Model: 175T – 750T

Product Bulletin # **TDS-183**

Inspect Die Blocks

Figure 1: Safety Wiring for Bolts on Die Block (Top)

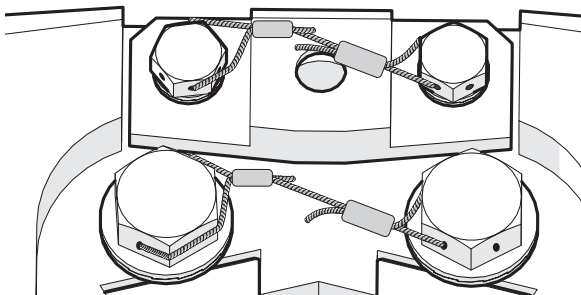
The Back-Up Wrench (BUW) gripper dies on the die blocks can fall to the rig floor if fasteners become loose or detached. Additionally, there is potential for the die block dies and fasteners to be exposed and impacted by the drill pipe if the stabbing bell has too large of a bore for the drill pipe being used. Generally, the stabbing bell bore should be no more than 1/2" larger than the drill pipe.

- Visually inspect the die block assemblies. This includes the die block, dies, retainers, fastening hardware, and secondary retention. Ensure these components have not been loosened or damaged.
- Measure the stabbing bell bore to ensure the bore size is within 1/2" of the drill pipe diameter and replace the stabbing bell if the bore is oversized for the application.

- Replace all damaged components with new components.
- Replace all loose or damaged fasteners with new fasteners.
- When replacing fasteners, add Loctite[®] or equivalent to the fasteners and re-torque to the appropriate torque value as per **Canrig Capscrew Torque Values specification ENG 725**.
- Safety wire all fasteners as per **Canrig Safety Wiring specification ENG 701**.
